**WARRANTY
 BULLETIN**

Wb05-03

DATE : MARCH 2005	SECTION : 05 - Cooling
EXPIRATION: MARCH 2007	
SUBJECT: REPLACEMENT OF THE BELT TENSIONER AIR BELLOWS ATTACHMENT BRACKETS

FIGURE 1

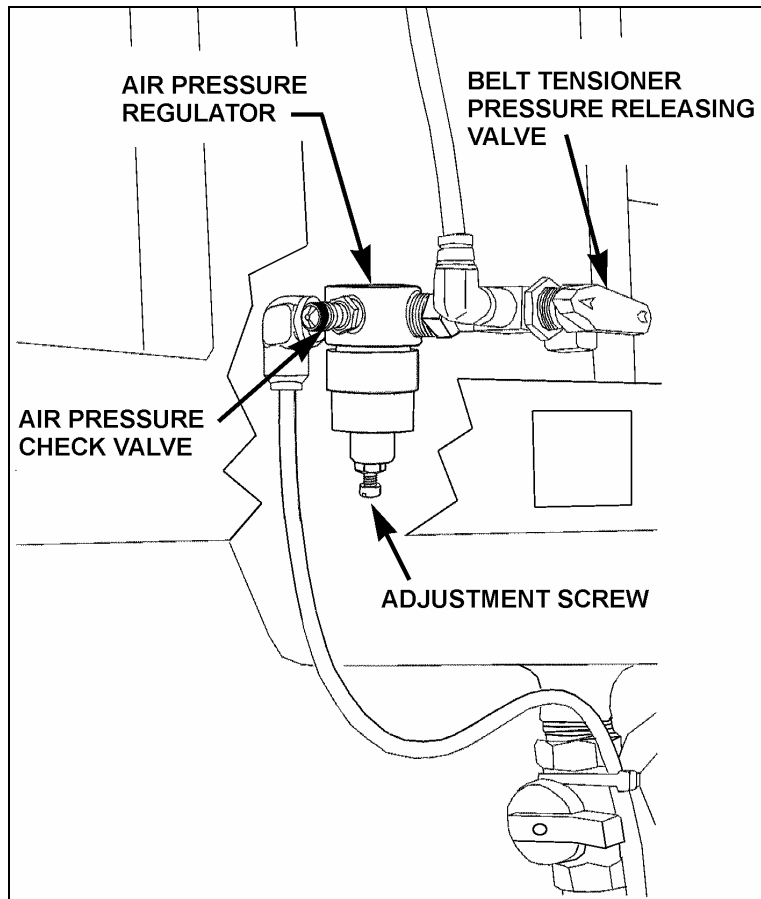
1. For parts replacement, air pressure must be released from bellows by turning the belt tensioning pressure control valve counterclockwise. This valve, mounted close to the pressure regulating valve, is manually operated. Before handling, set the rear start switch to OFF and observe all applicable safety precautions (Refer to figure 1).

FIGURE 2

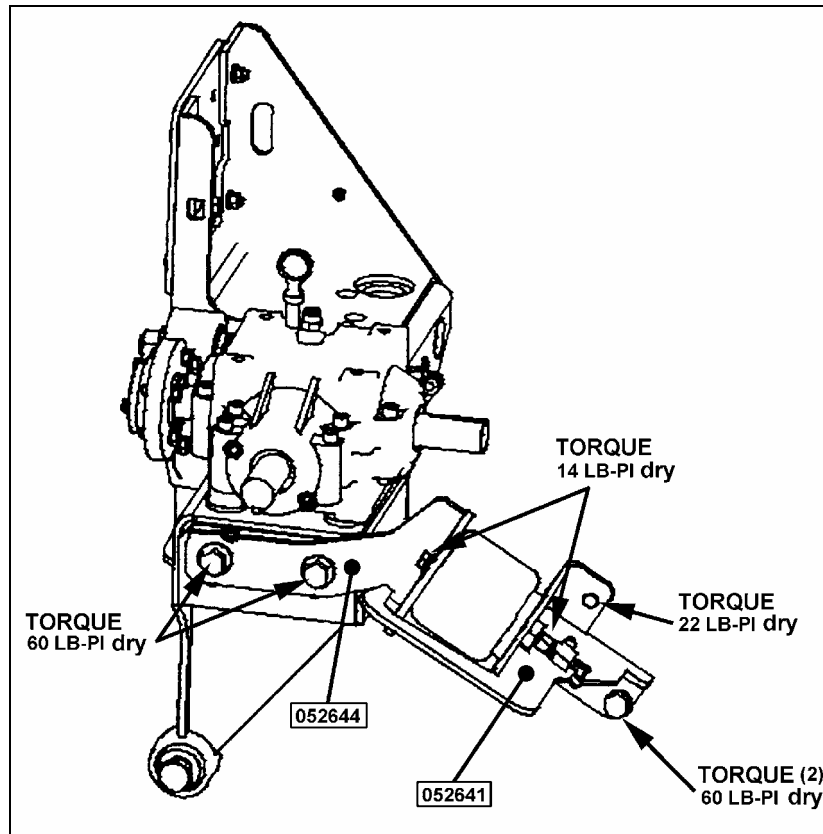
2. Disconnect the air lines then remove the air bellows fittings.
3. Dismount the air bellows attachment brackets (Refer to figure 2).
4. Reinstall the air bellows with the new attachment brackets (052641 & 052644). Tighten the bolts to the specified torque as per figure 2.
5. Check if the air bellows (550840) and belts (505522) were damaged as shown in figure 3, replace as needed.
6. Reinstall the air bellows fittings. Use some Teflon tape on the threads.
7. Turn the belt tensioner pressure releasing valve clockwise to initial position to reapply tension on the belts 50 lb/in² (345 KPa).
8. Check if the distance between the air bellows top plate and the stop is approximately 13/32" (10 mm) (Refer to figure 4).

FIGURE 4

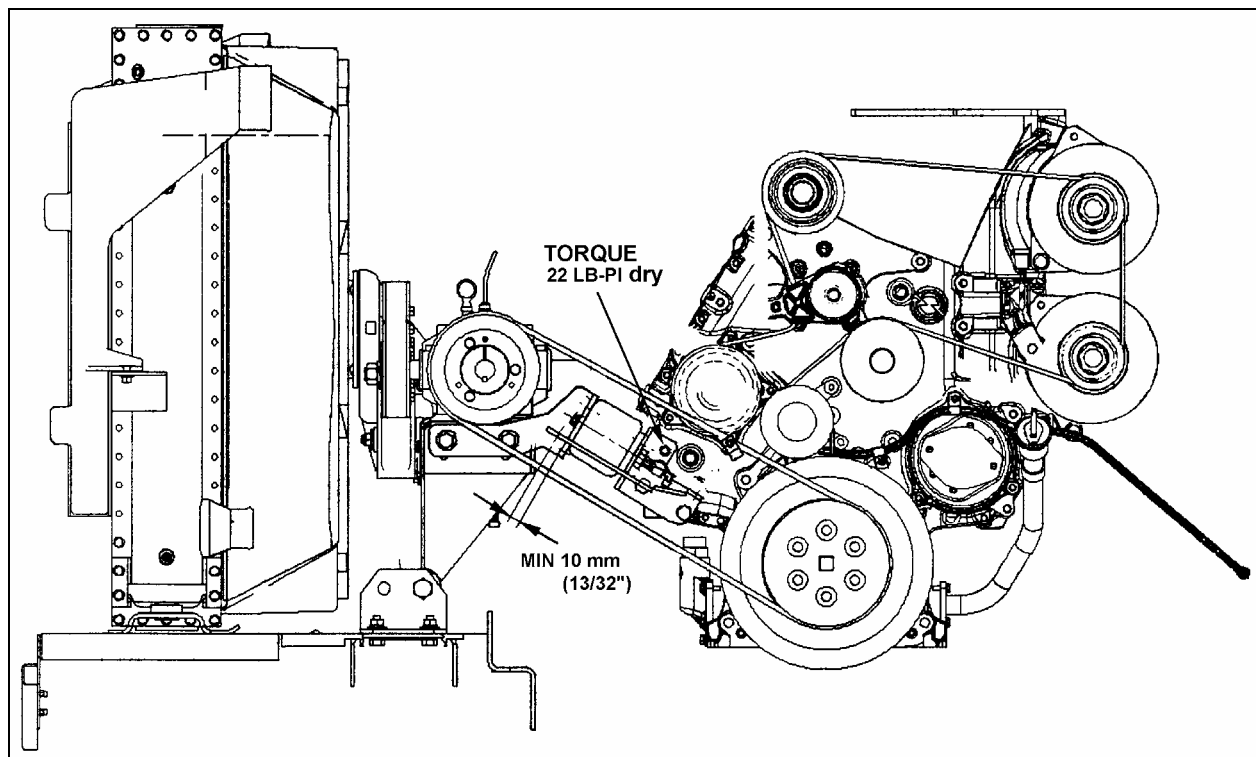
9. If the distance is not as specified, release pressure from the air bellows. Loosen the bolts on the gearbox side attachment bracket, adjust the position of the attachment bracket then tighten the bolts. Reapply the air pressure and check the distance once again. Correct as necessary.

FIGURE 5

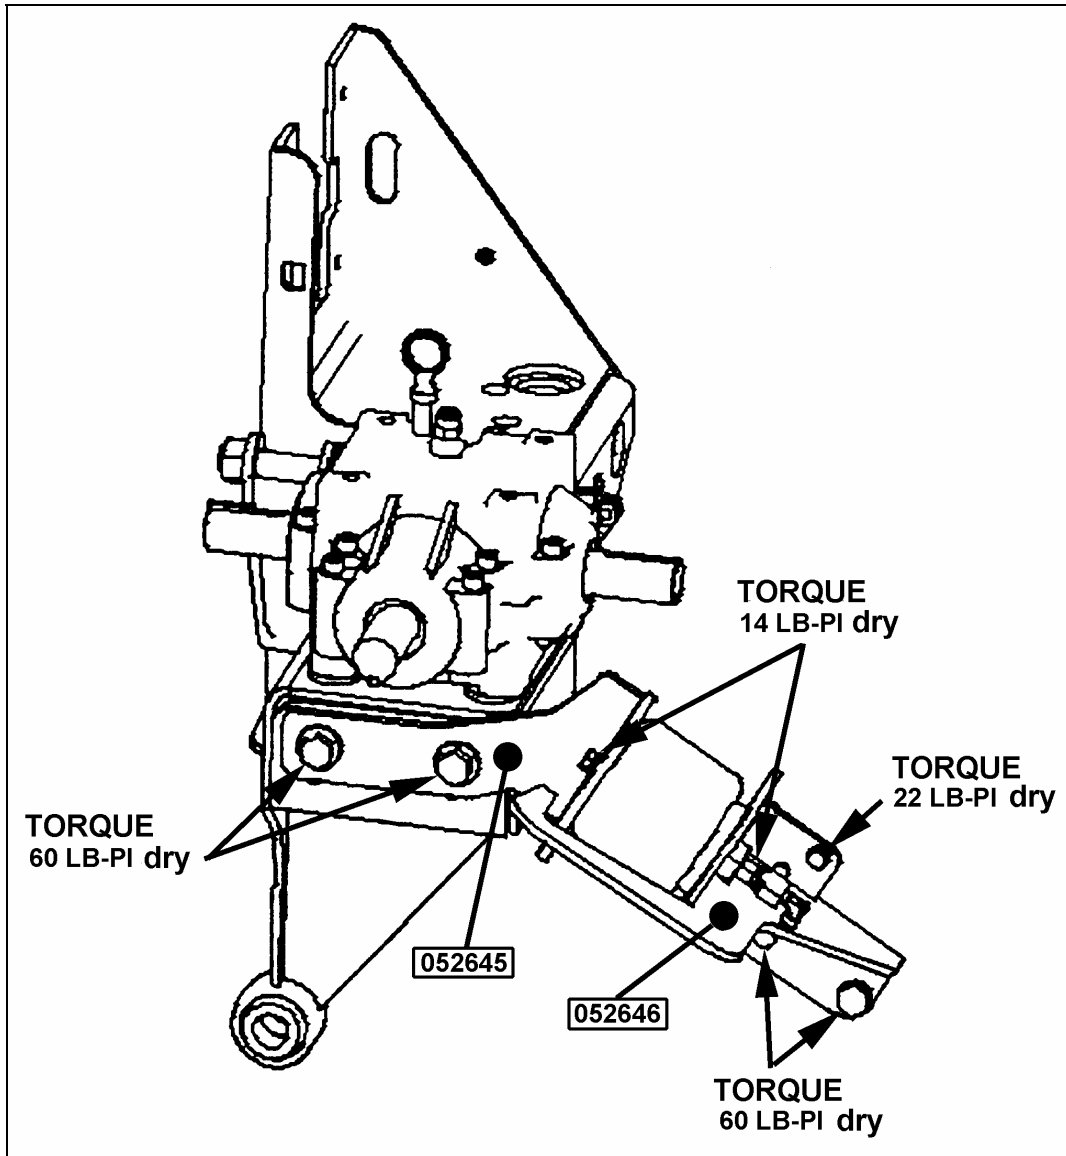
2. Disconnect the air lines then remove the air bellows fittings.
3. Dismount the air bellows attachment brackets (Refer to figure 5).
4. Reinstall the air bellows with the new attachment brackets (052645 & 052646). Tighten the bolts to the specified torque as per figure 5.

FIGURE 6

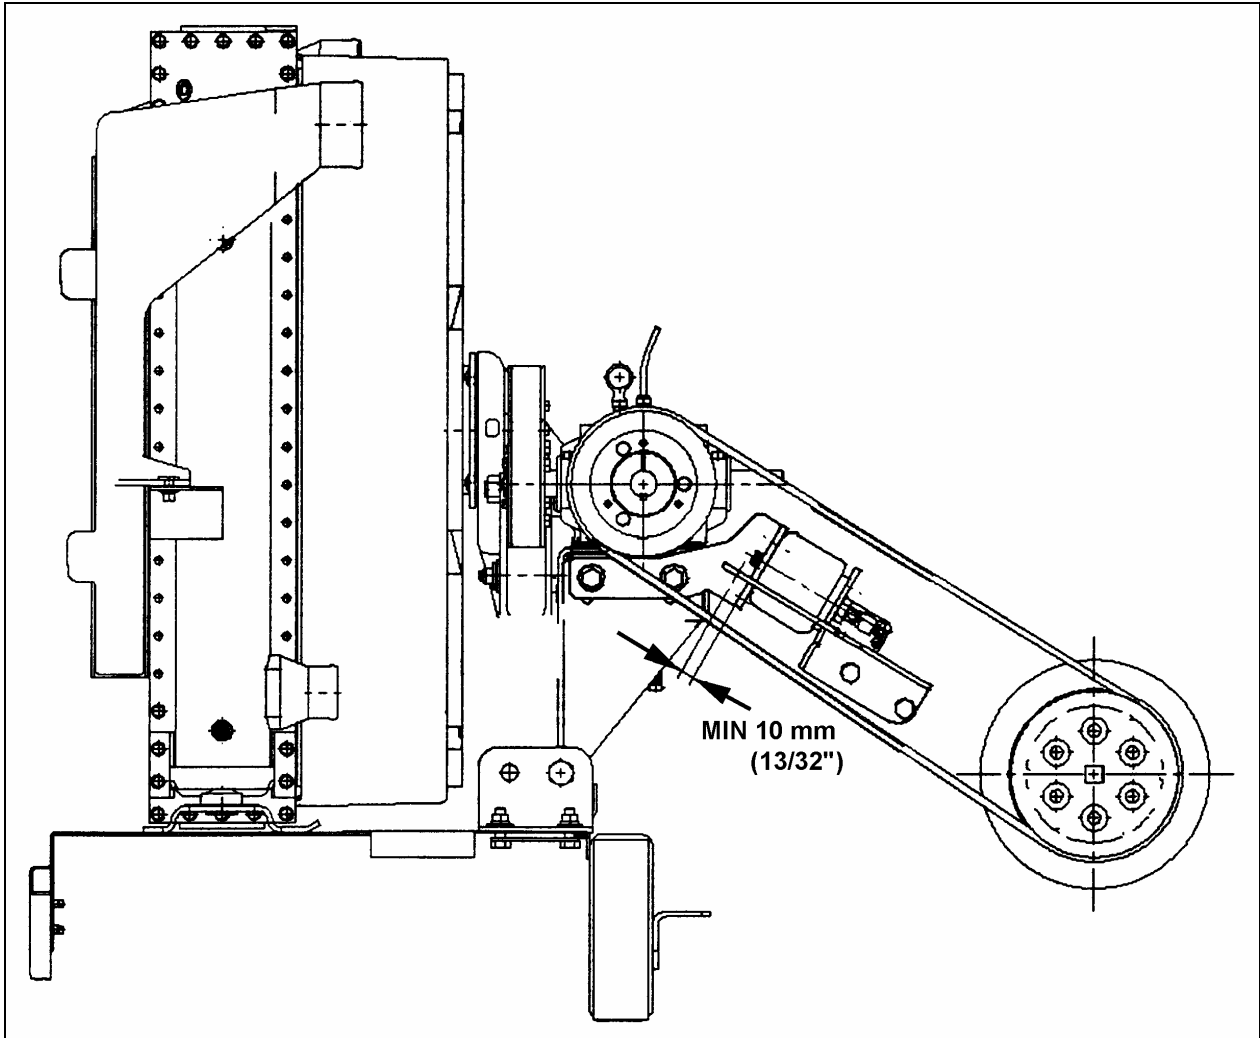
7. Turn the belt tensioner pressure releasing valve clockwise to initial position to reapply tension on the belts 50 lb/in² (345 KPa).
8. Check if the distance between the air bellows top plate and the stop is approximately 13/32" (10 mm) (Refer to figure 6).

- If the distance is not as specified, release pressure from the air bellows. Loosen the bolts on the gearbox side attachment bracket, adjust the position of the attachment bracket then tighten the bolts. Reapply the air pressure and check the distance once again. Correct as necessary
